ADDENDUM NO. 01

July 24, 2026

**Bradford Exempted Village Schools
New Athletic Facility
760 Railroad Avenue
Bradford, OH 45308**

LPA PROJECT NO. 263401.00

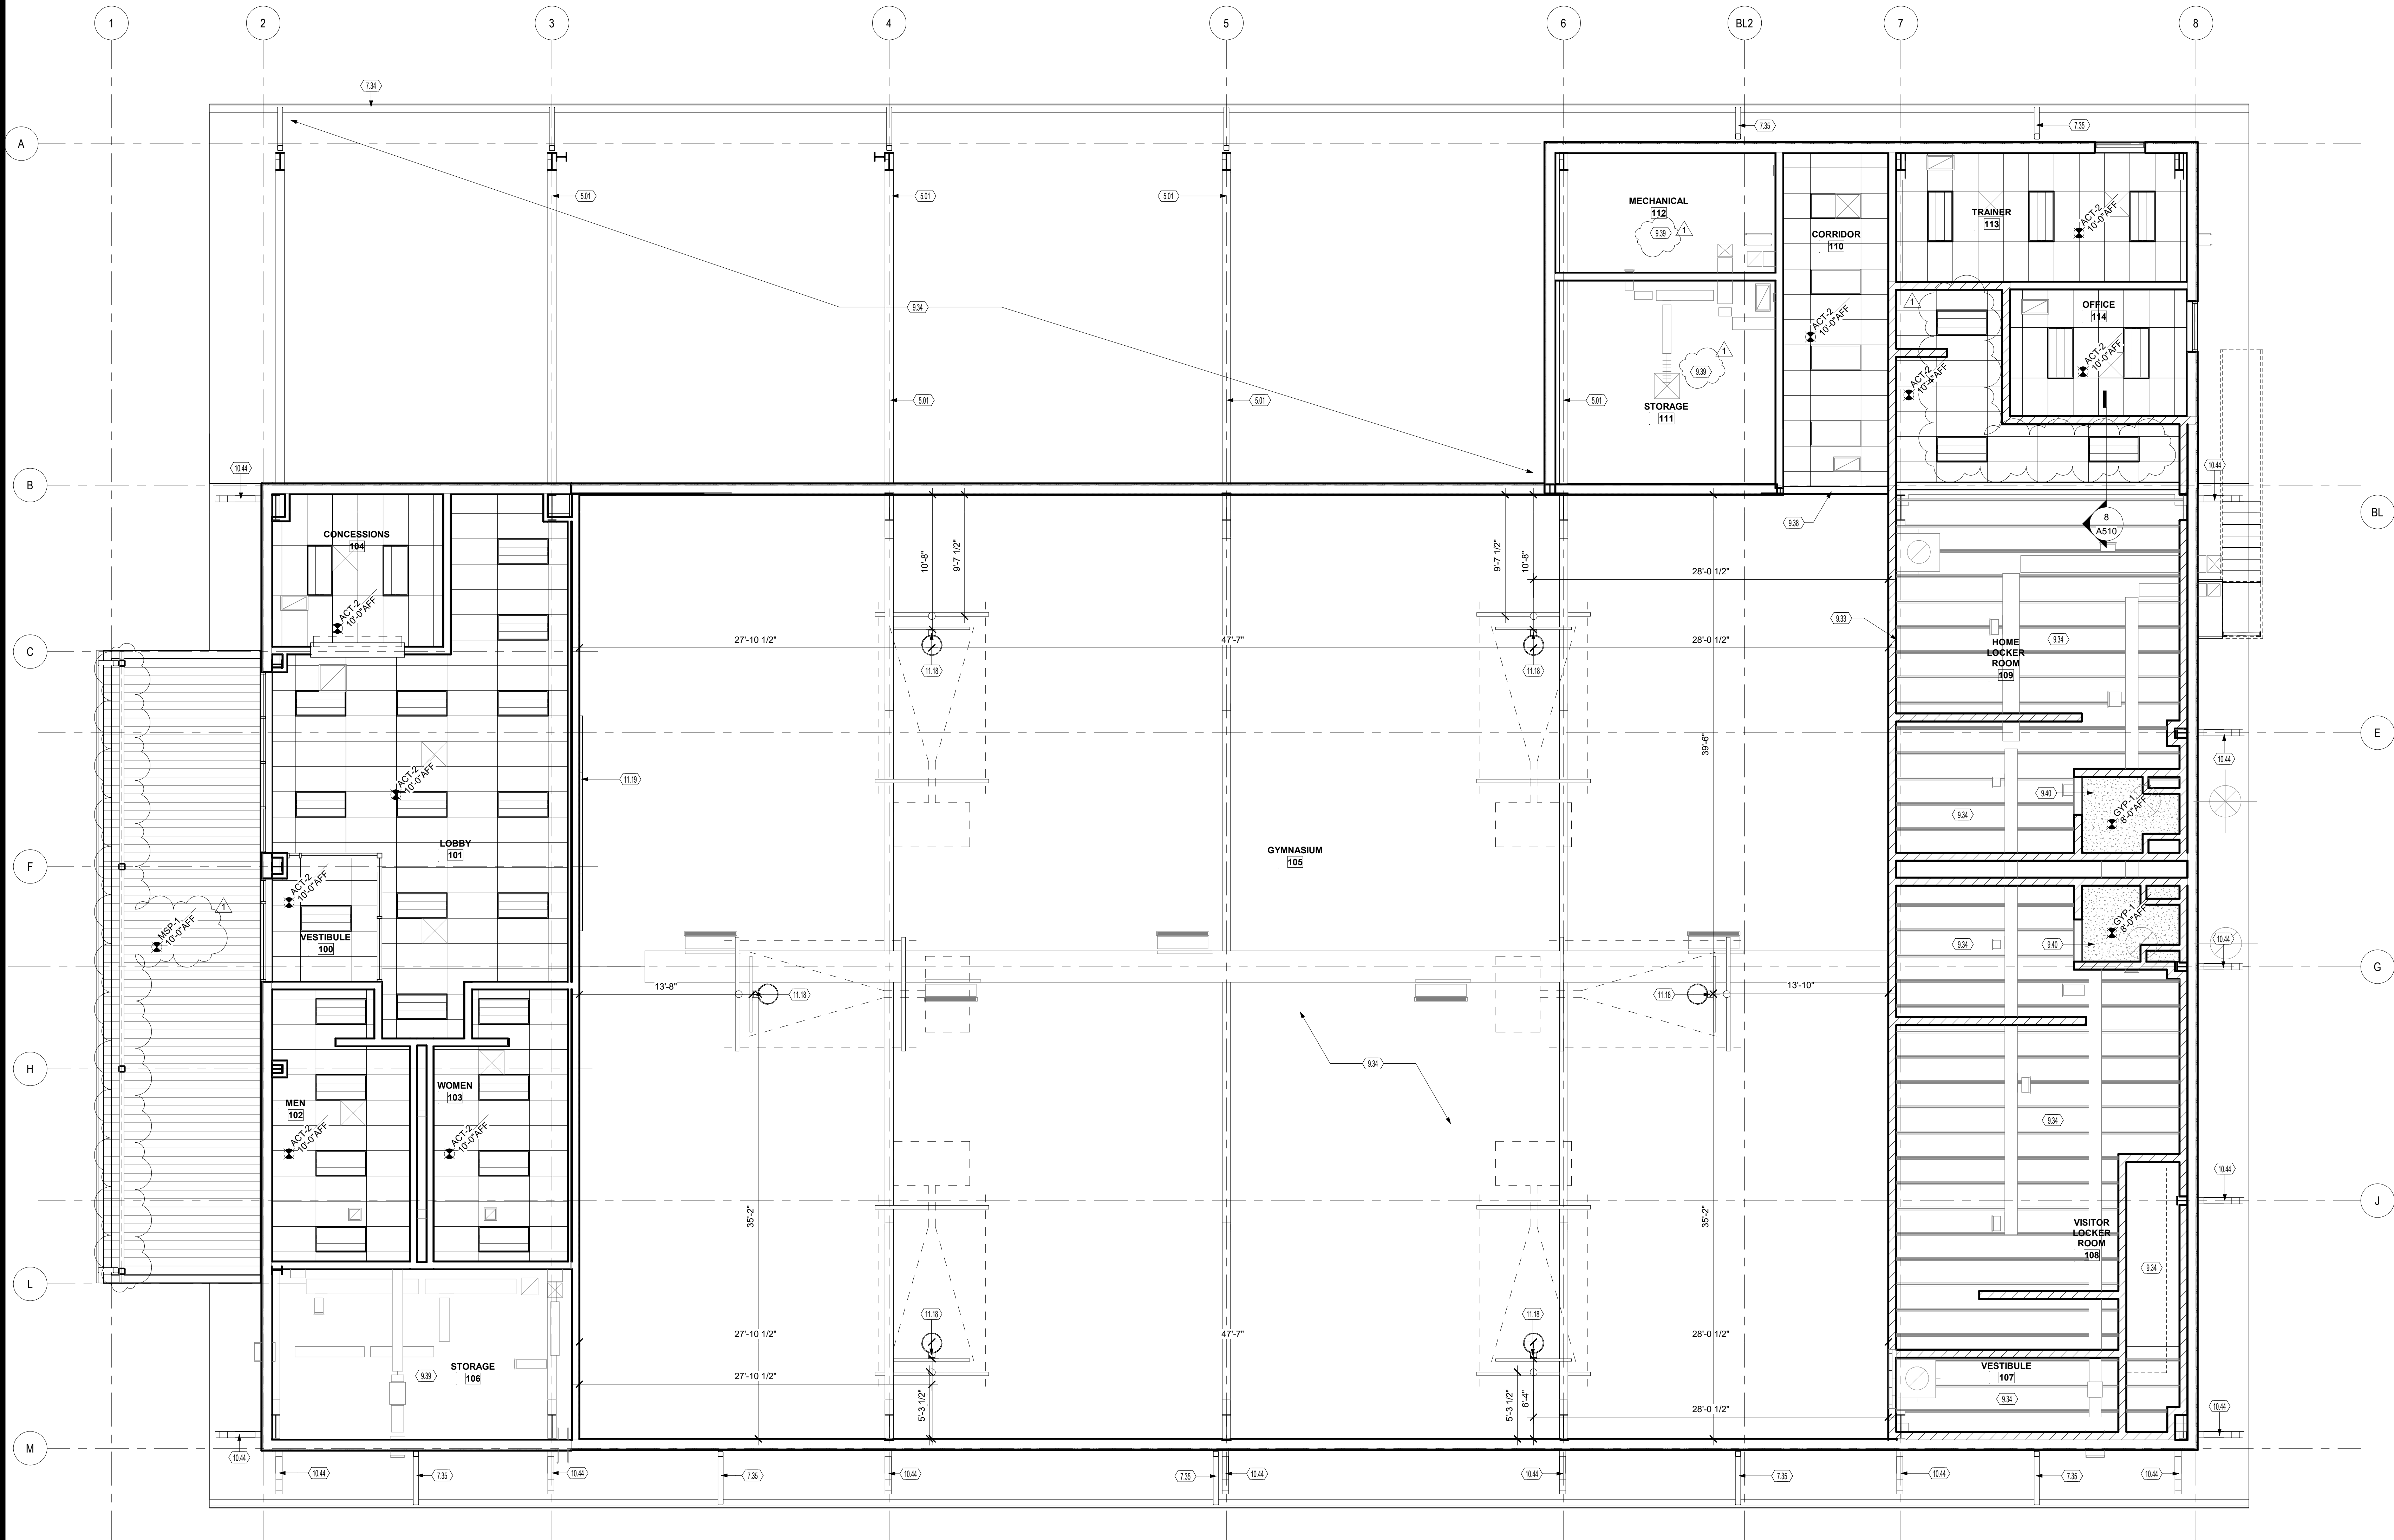
2.5 Sheet A121 – REFLECTED CEILING PLAN.

- 2.5.1 Clarified soffit material at the main entry canopy.
- 2.5.2 Showed a steel beam for the canopy framing support. Steel beam shall be by PEMB manufacturer as indicated. Size to be determined by PEMB manufacturer.
- 2.5.3 Revised lighting layout in the Home Locker Room 109 at the ACT ceiling to match the electrical drawings.

28 SPLIT FACE WAINSCOT @ GYM
SCALE | 1 1/2" = 1'-0"

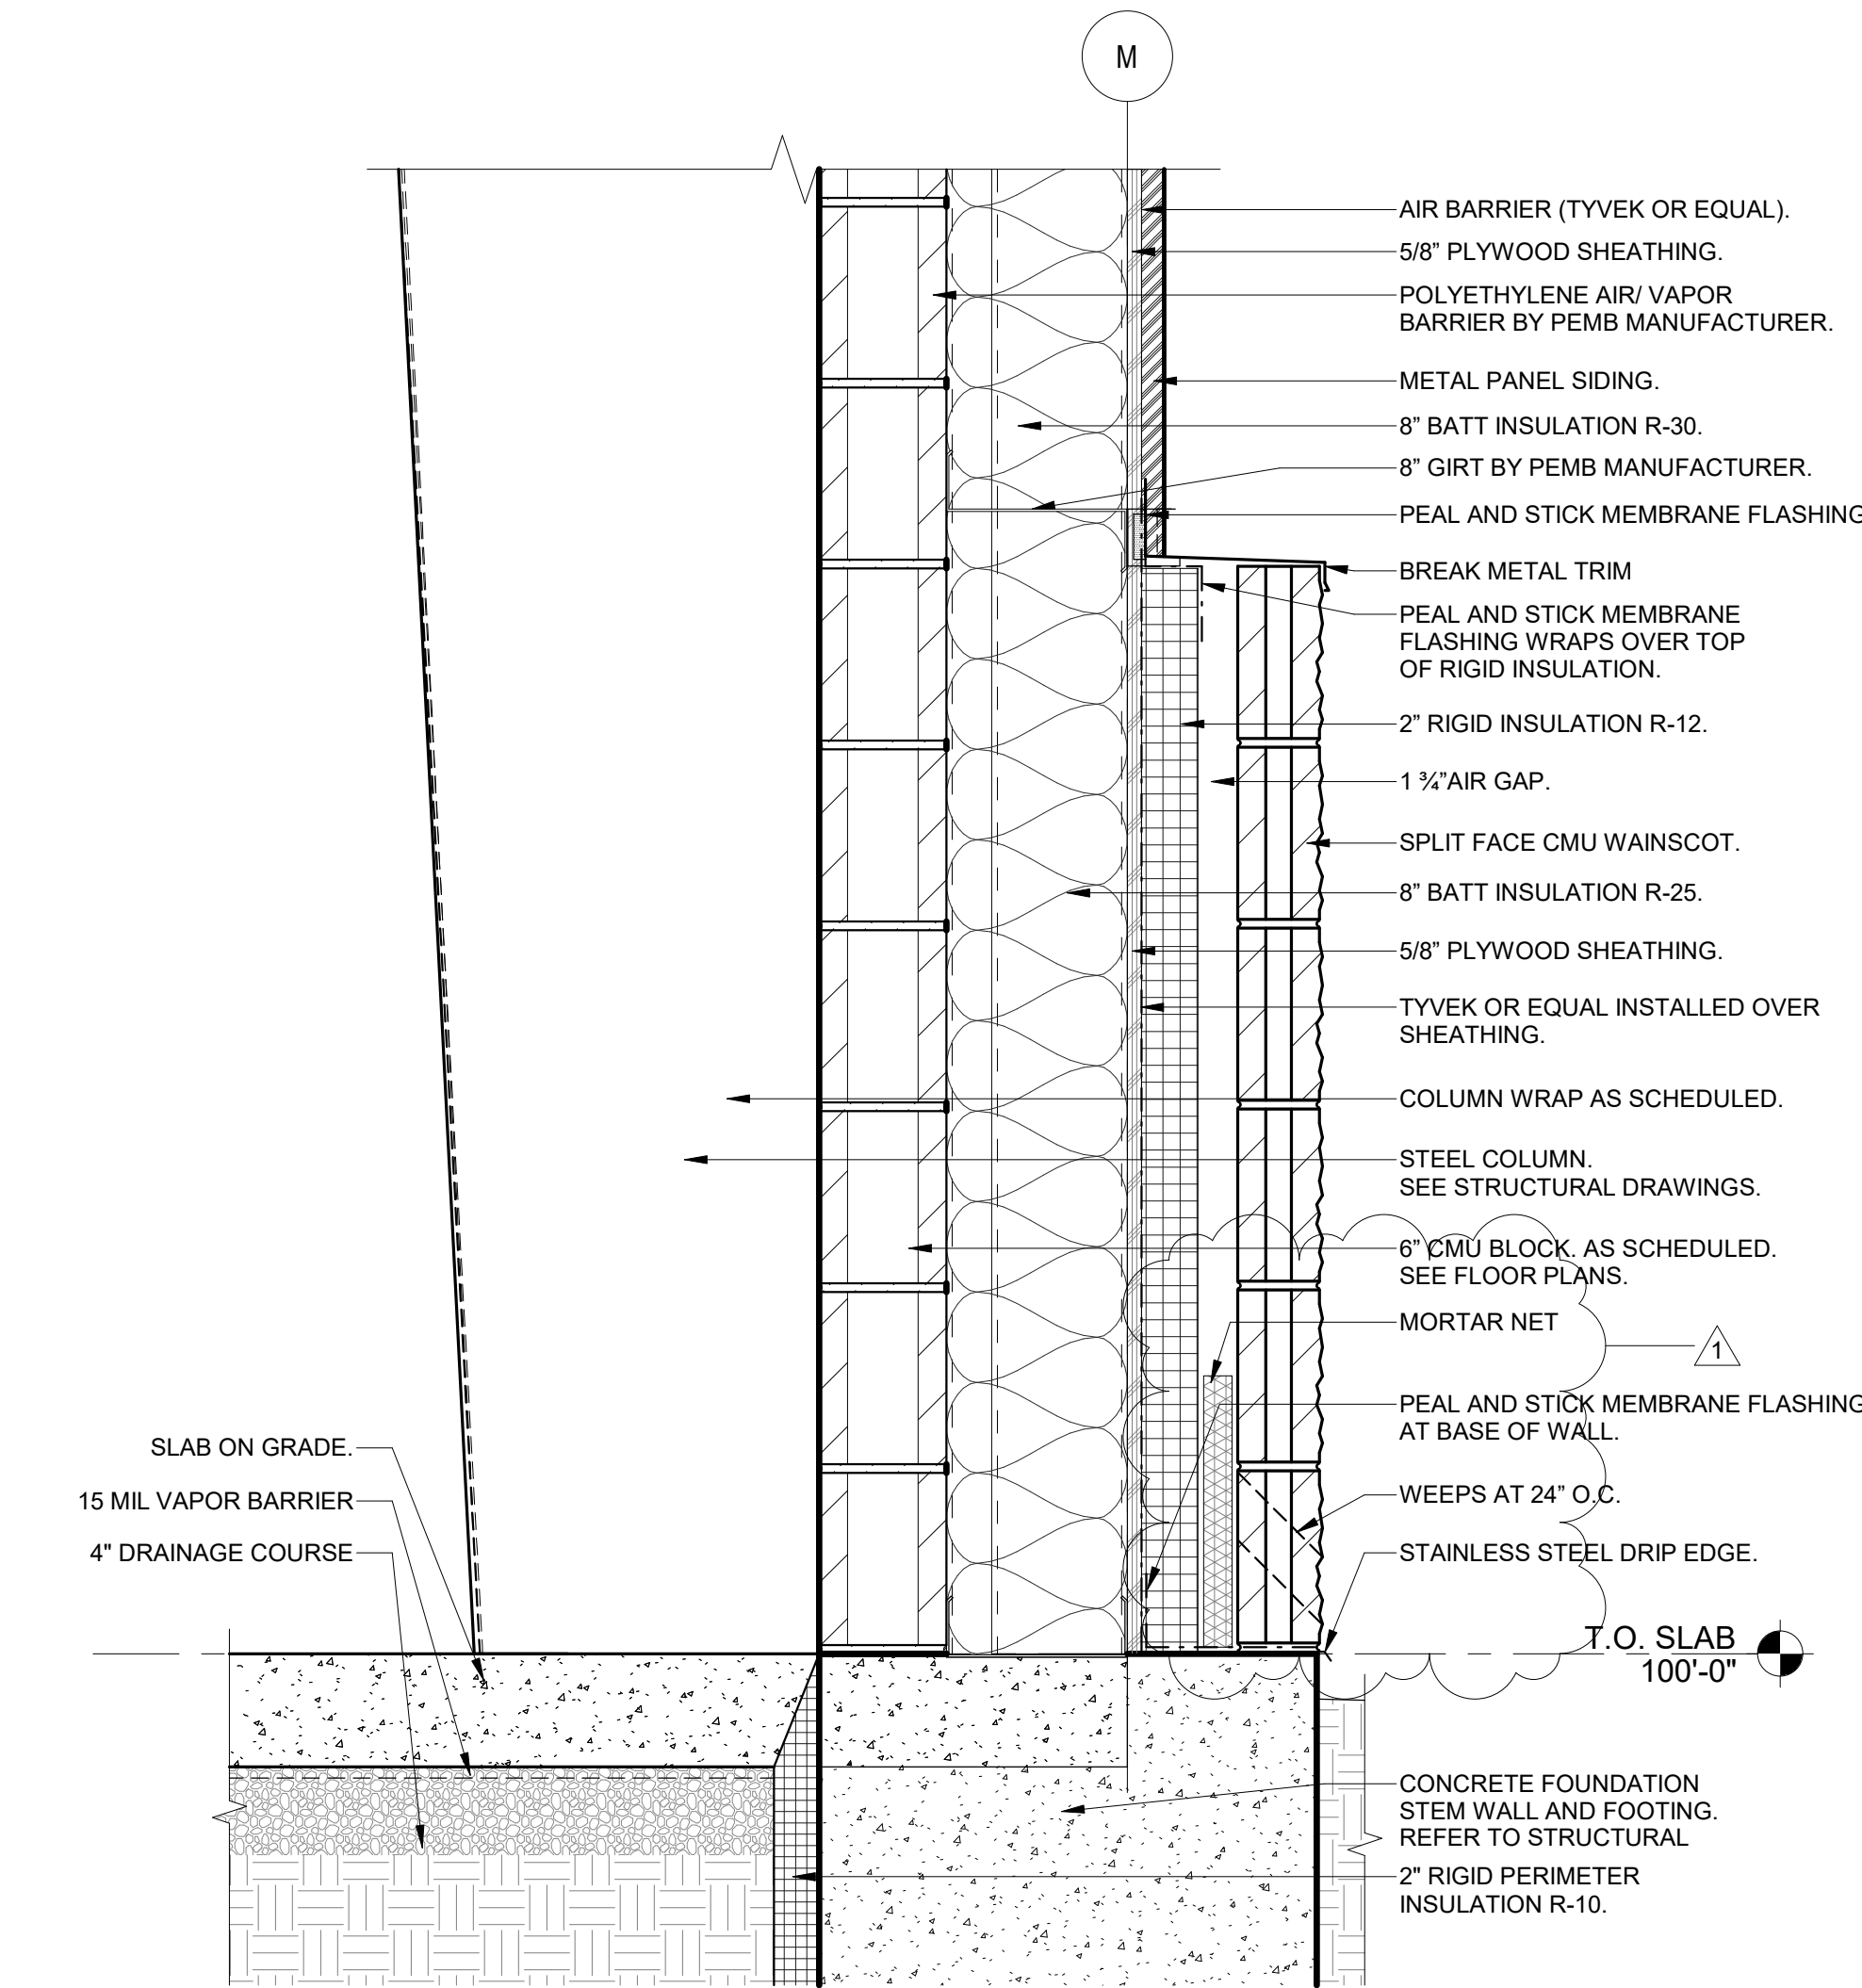
- 2.17.1 Added mortar net behind the split face CMU in detail 28.
- 2.18 Sheet A502 – EXTERIOR DETAILS.
 - 2.18.1 Revised detail 9 to reflect R-30 batt insulation.

26 MAIN ENTRY CANOPY SECTION

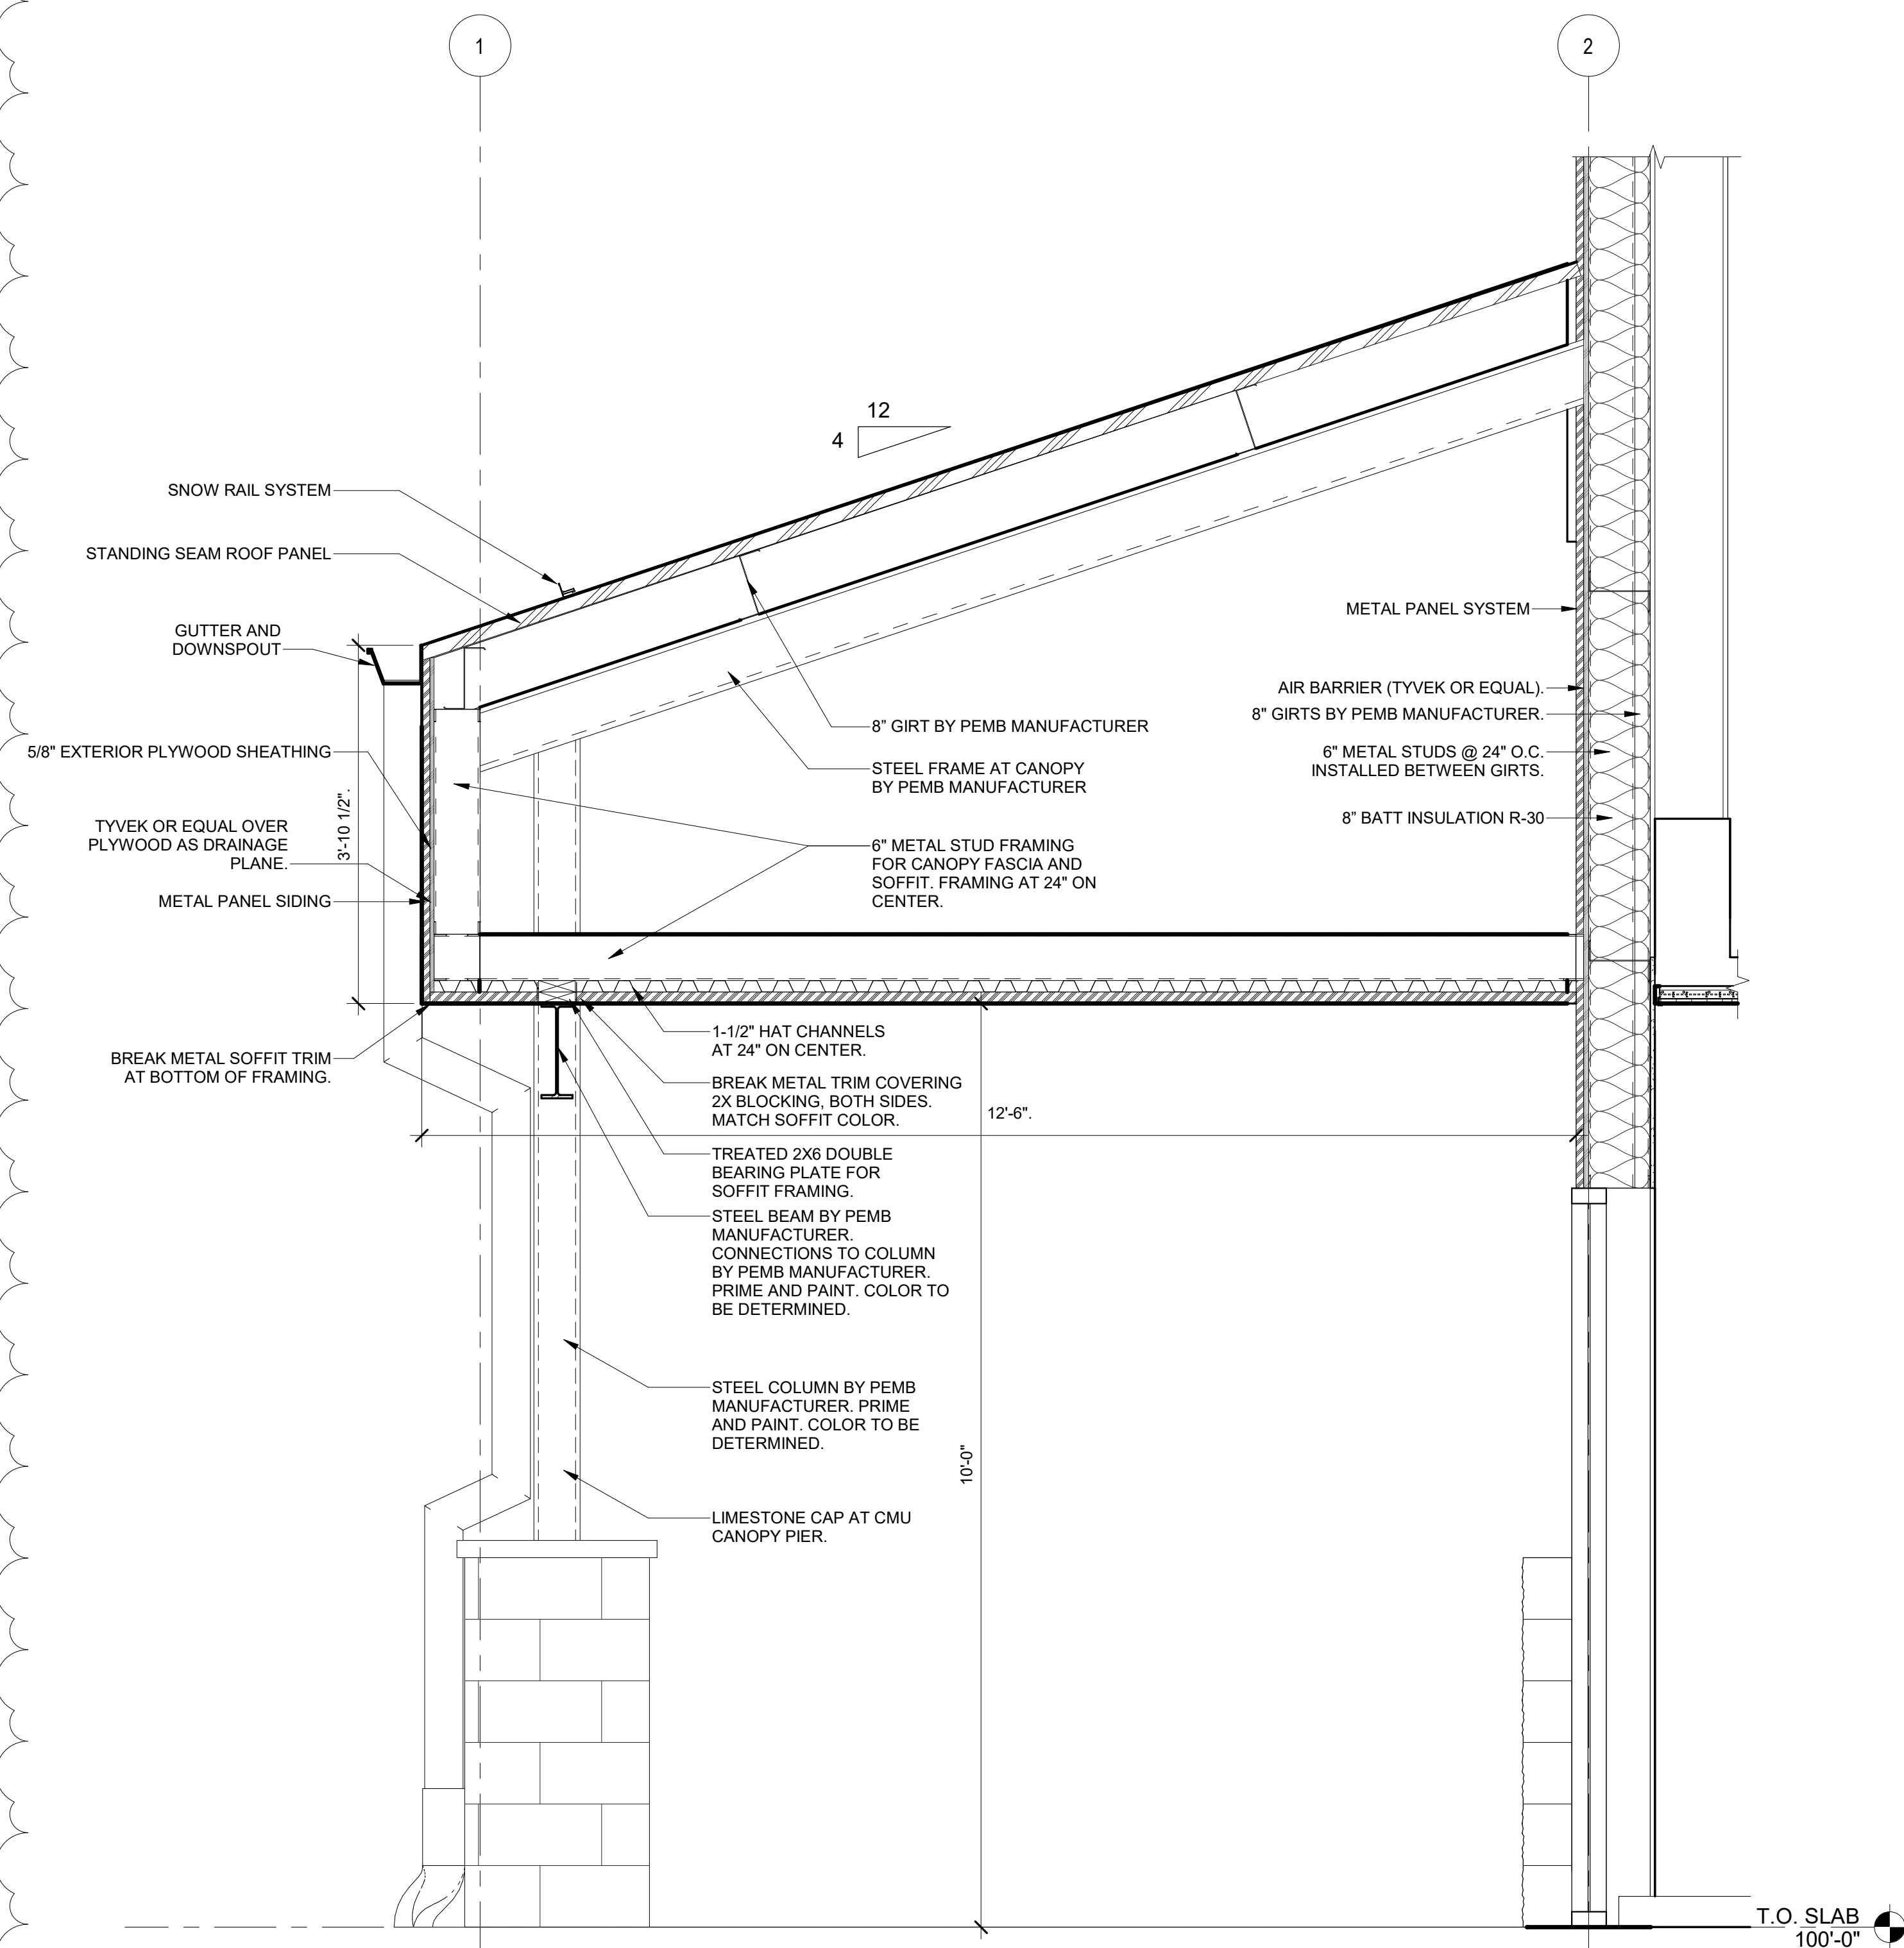
1.6 Question: On sheet A121, what is the ceiling on the front entrance canopy?

2.19.1 Added Section 26 for the main entry canopy.

1.6.1 Response: The ceiling for the front entrance canopy is a metal panel soffit similar to Berridge L-Panel with an embossed stucco texture and vee grooves. This will be installed on 6" metal studs at 24" on center with 1-1/2" hat channel furring at 24" on center. See attached detail 26 on sheet A503 for the section / detail.
